**TECHNICAL GUIDANCE COMMITTEE
FOR INDIVIDUAL AND SUBSURFACE SEWAGE DISPOSAL**

December 02, 2003 MEETING MINUTES

FINAL TGC minutes 12/02/03

7. Dosing Chamber:

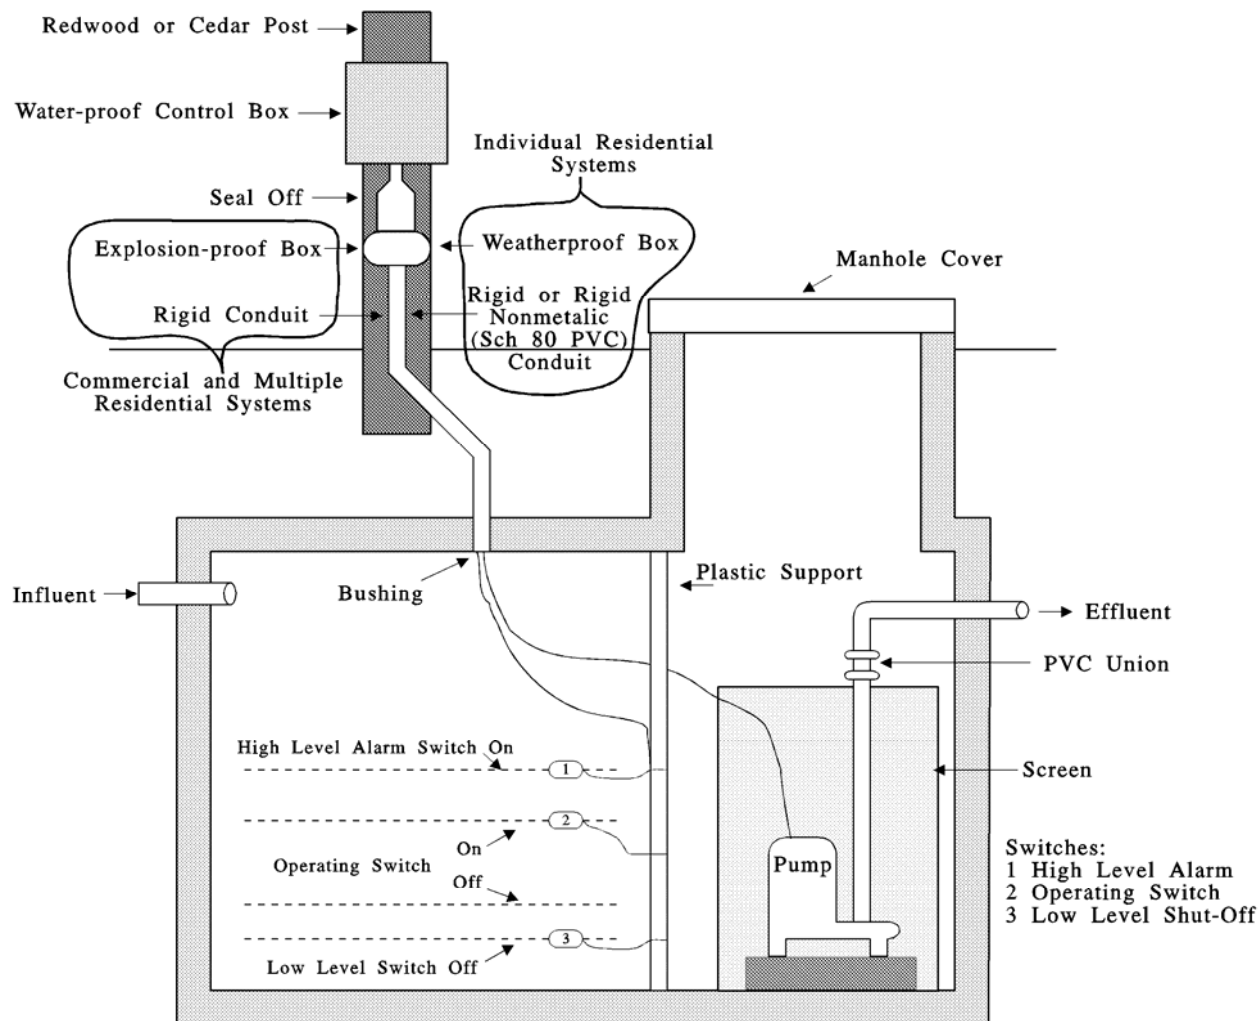
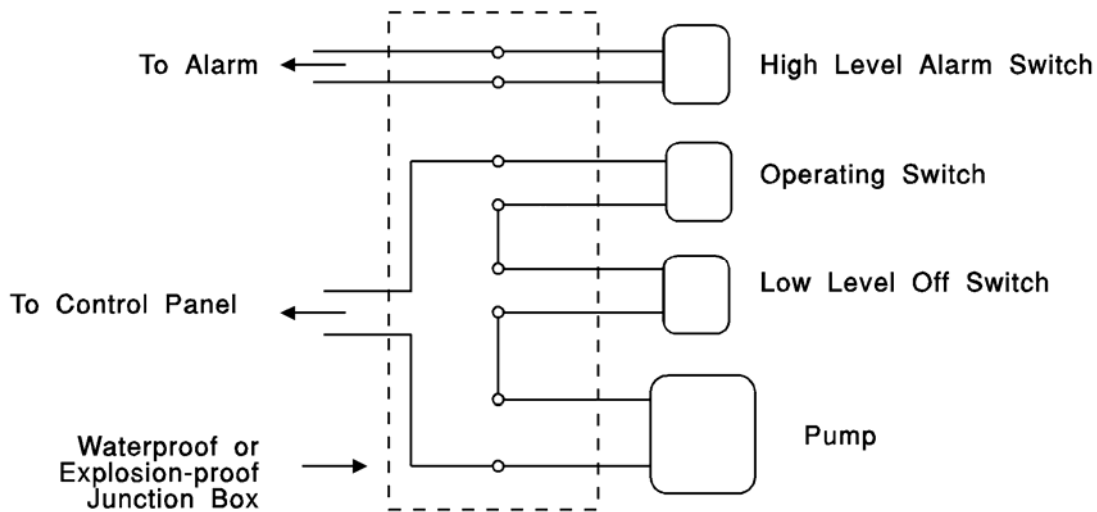
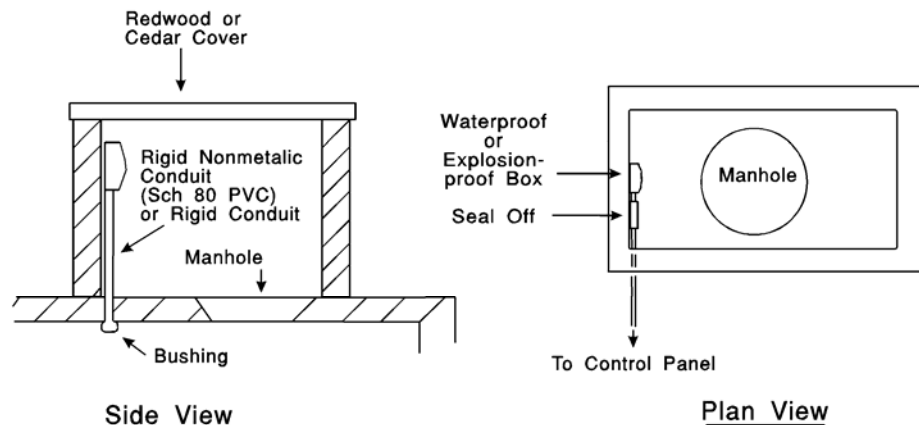
The Committee discussed the proposed revisions to the pressure distribution system section regarding pumps and electrical code. The change is to modify the dosing chamber design section #7 description for electrical requirements of individual residential systems and commercial or multiple residential systems. The three figures in design section #7 Dosing Chamber have been modified to reflect these changes..

For individual residential systems the electrical connection for the pump can be made in a weatherproof box and the electrical wires can run through rigid non-metallic conduit such as Schedule 80 PVC.

For commercial or multiple residential systems the electrical connection for the pump must be made in an explosion proof box and the wires must run through a rigid conduit.

- Revise the figure to indicate that a weatherproof box is acceptable for individual residential systems and that the conduit can be rigid non-metallic schedule 80 PVC. Note that the explosion-proof box is required for multiple residential and commercial applications.

- Revise language in 2) to reflect changes in electrical requirements and suggested language changes from the Electrical Bureau.
- Revise figure in 4) by adding “weatherproof or” to text describing electrical box (TGM page 59).
- Revise language in 5) and 6) to refer to the Division of Building Safety, Electrical Bureau.
- Revise figure in 6) to indicate the use of rigid or rigid non-metallic (SCH 80 PVC) conduit is acceptable materials to run electrical wire, and add weatherproof to the descriptor for the connection box.

- 2) All electrical connections must be made outside of the chamber in either an approved weatherproof box or an explosion-proof junction box (Crouse-Hind Type EAB or equivalent). The lines from the junction box to the control box must pass through a sealing fitting (seal-off) to prevent corrosive gases from entering the control panel. All wires must be contained in solid conduit from the dosing chamber to the control box.
